EB-2023-0336
OPG – MRP and DVA Proceeding

Interrogatories of Environmental Defence

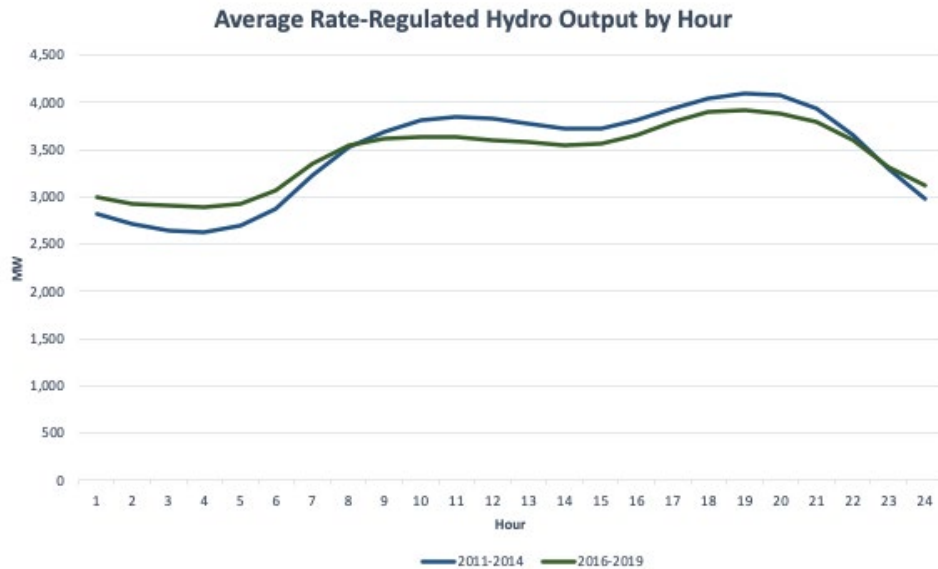
- (a) Attachment three only provides evidence on the pump generations station. For OPG's whole fleet, please "identify each time that OPG did not operate its regulated fleet to minimize total electricity supply costs during hours when OPG is booking additions to this variance account because doing so would cause OPG to experience an economic loss, and explain why operating to minimize total electricity supply costs would have caused economic loss in each case" – as required by the settlement agreement.

OPG Regulated Hydro Facilities – Average Output by Hour

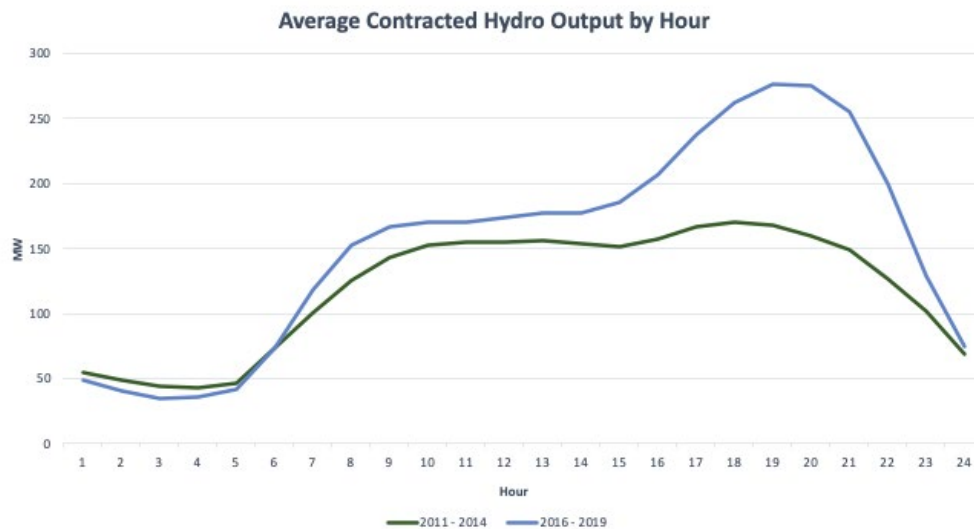
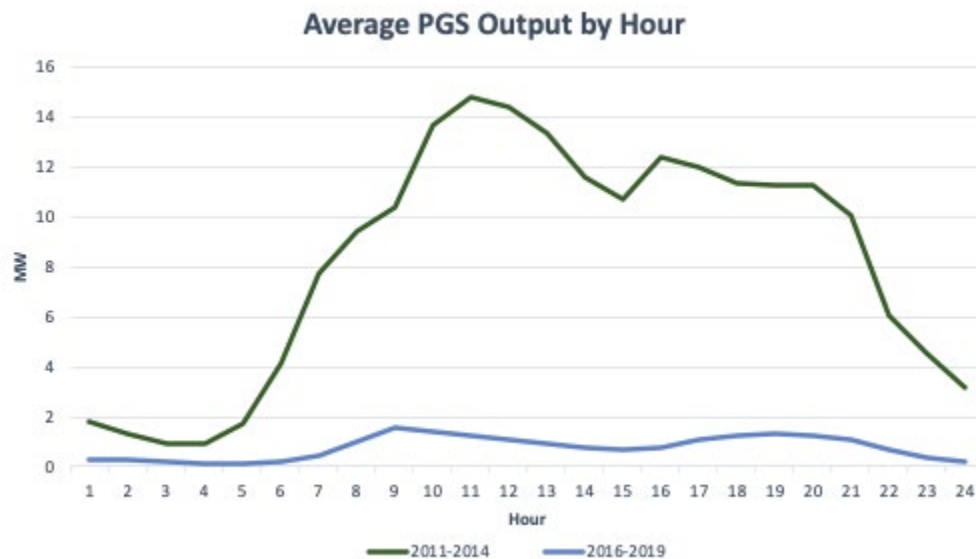
The below figures show the average output of OPG's rate regulated vs. unregulated hydro assets.

- (a) Please reproduce the above figures adding a line for 2020-2023
- (b) Please explain why OPG time-shifted its output for its regulated hydro assets less in 2016-2019 versus 2011-2014 (as shown by the flatter curve in the top figure). Please enumerate all causes. Please also describe any differences arising in 2020-2023 versus previous periods, enumerating all the differences.
- (c) Please explain why OPG time-shifted its output for its regulated hydro facilities far less than the output of its unregulated hydro facilities (as shown by comparing the figures). Please enumerate all causes.

- (d) If OPG had time-shifted its regulated hydro facilities like it did its unregulated hydro facilities, how much less SBG costs would it be seeking in this application? Please provide an annual breakdown
